RE: Proposed Warehouse and Logistics Hub, 5 and 9 Culverston Road, Minto (SSD 7500)  
Response to Submissions

## Attachment 1

Drawing Title:  
Warehouse 1B & 1C  
B-Double Access

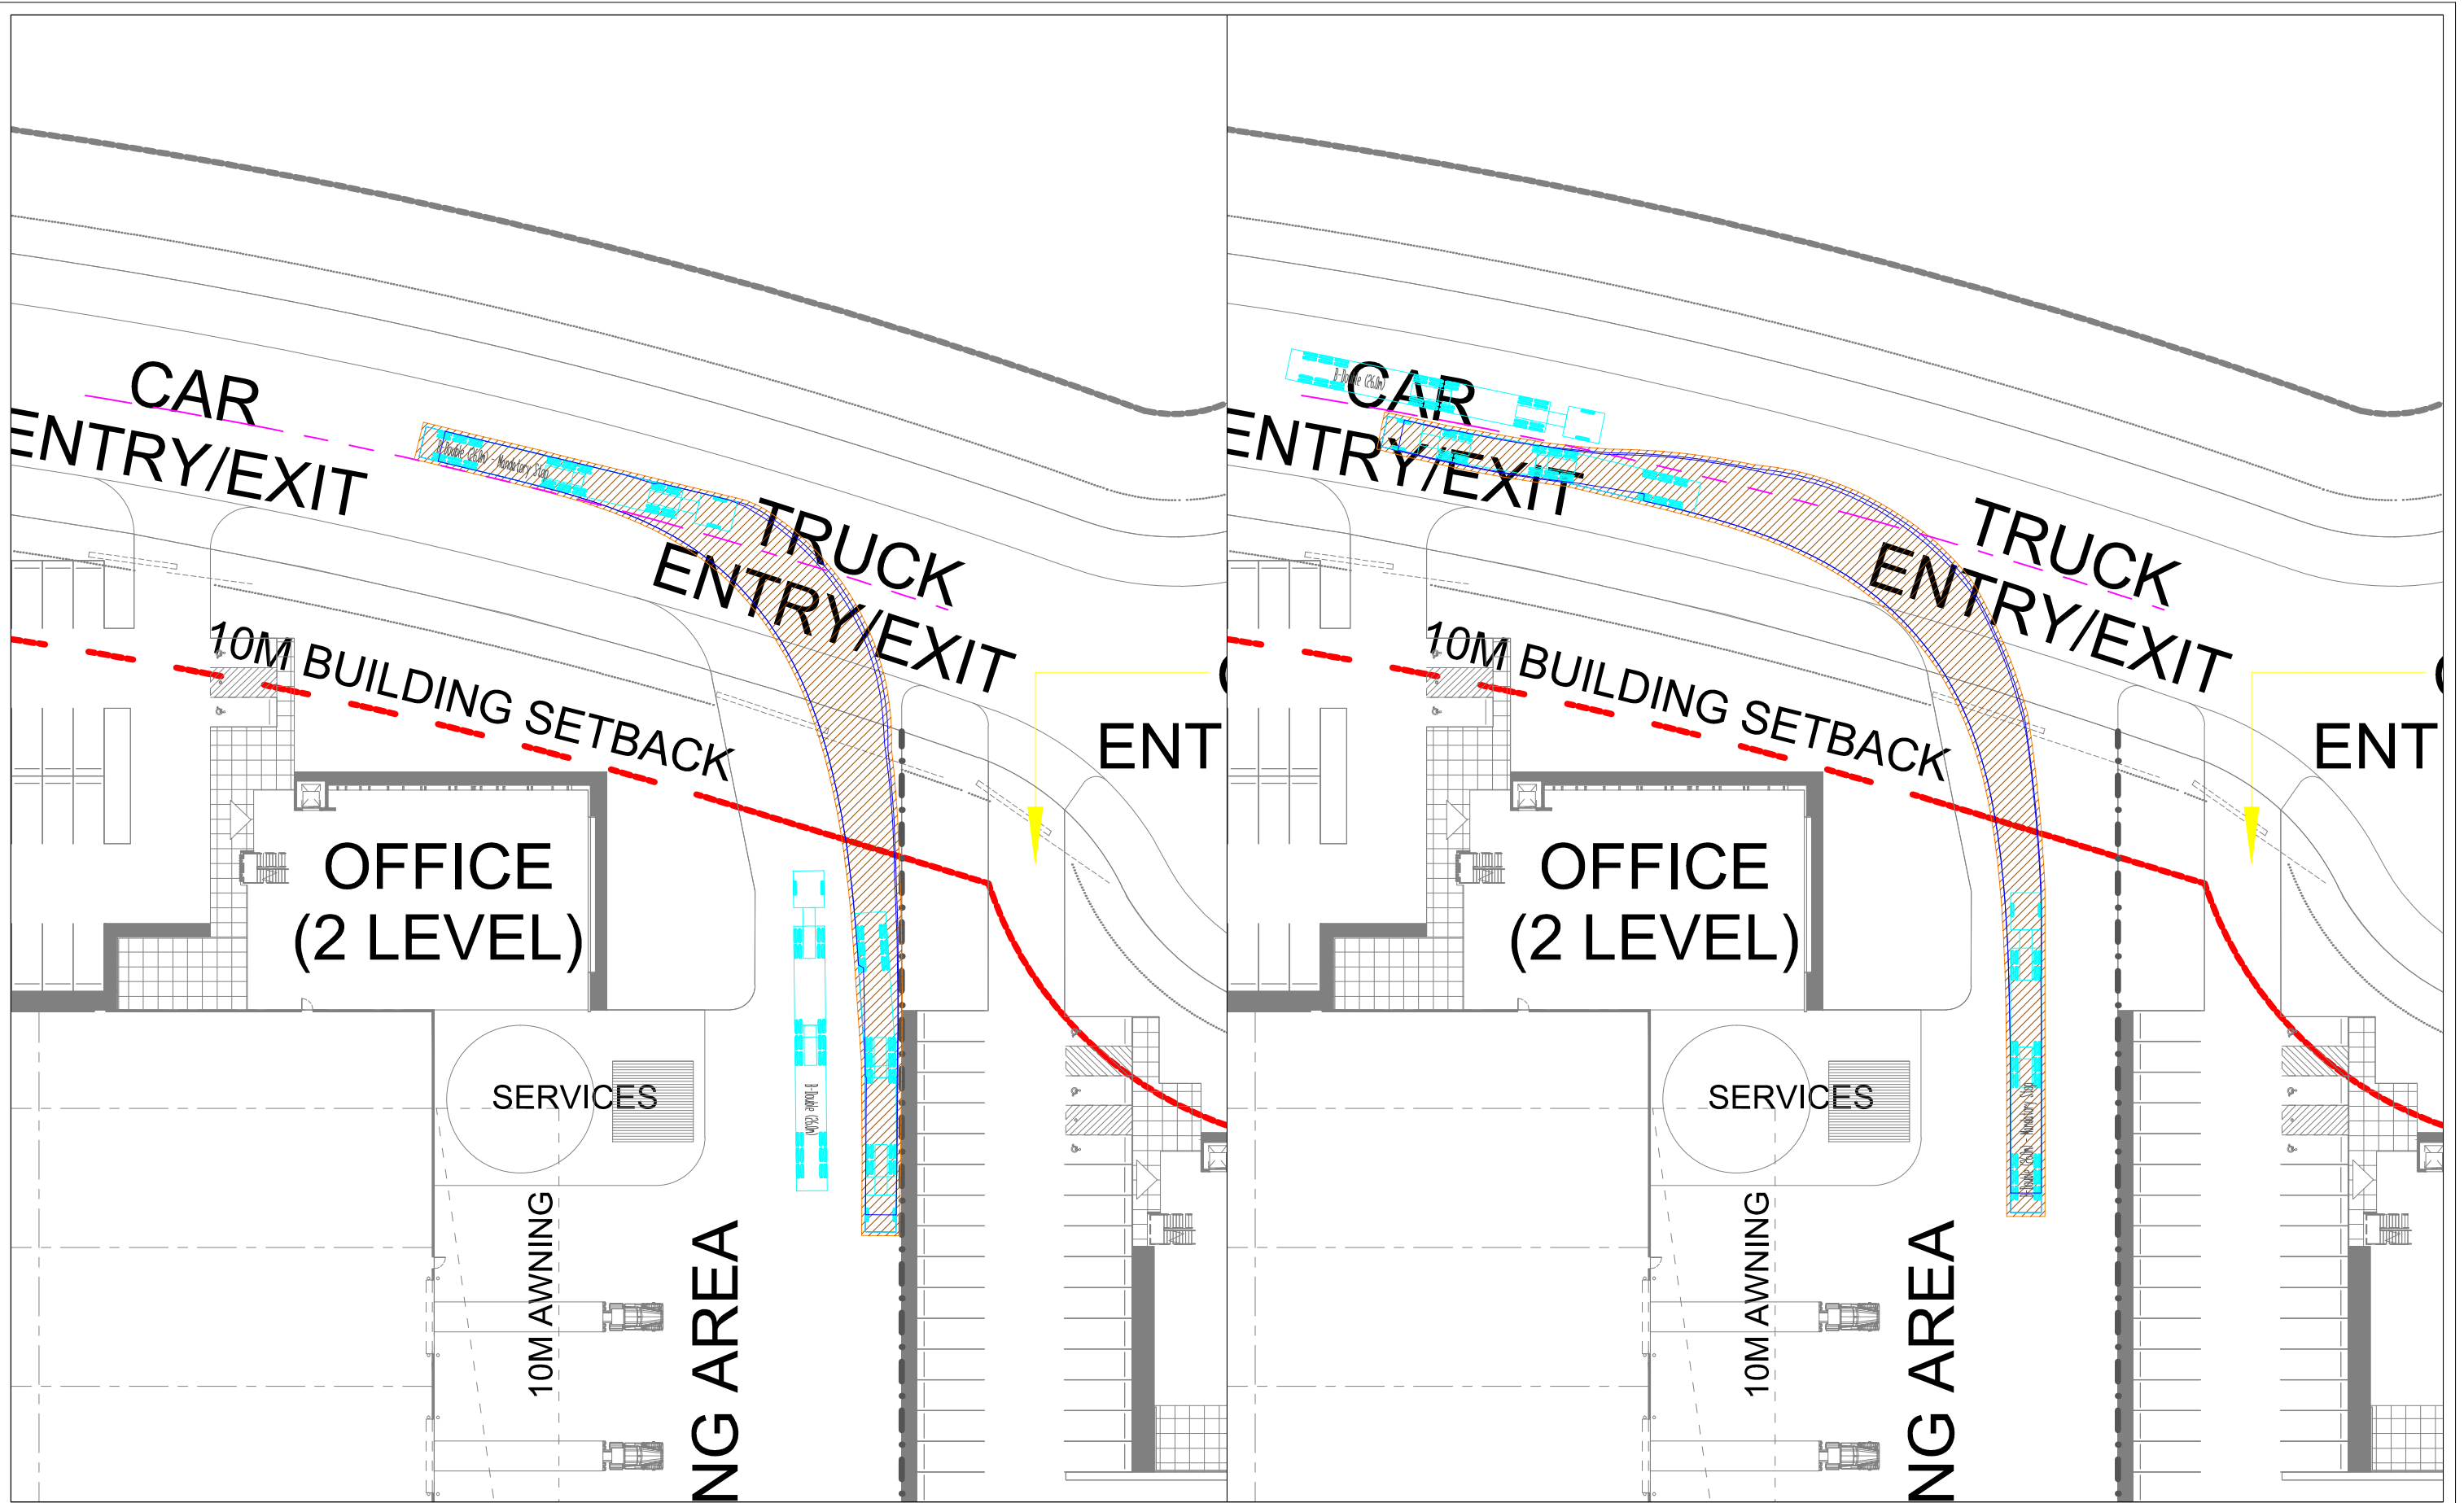
*All vehicle swept path analysis shall be undertaken using the longest design vehicle to access the site. All truck entries shall be designed in order to accommodate the opposing swept paths of the longest vehicle turning safely at the same time. In this regard, it is considered that for warehouses of the size proposed, B-double vehicles would be highly likely to use the site. Accordingly, a swept path analysis for full size B-doubles is required to be submitted to Council, to demonstrate that B-double combination vehicles will be able to access the site, manoeuvre satisfactorily, and safely leave the site in a forward direction.*

Concurrent B-Double access is not provided in the current design for Warehouses 1B, 1C and 1D as this would require excessive driveway widths which is considered undesirable due to the impact on the frontage. This is considered acceptable under AS2890.2 Clause 3.2.4 (b), which states “*The swept path of the maximum size design vehicle using the facility may be allowed to occupy the entire width (less specified clearances) of a two-way access driveway when the vehicle is entering or leaving the minor road*”. In this regard, **Attachment 1** details B-Double access to all warehouses.
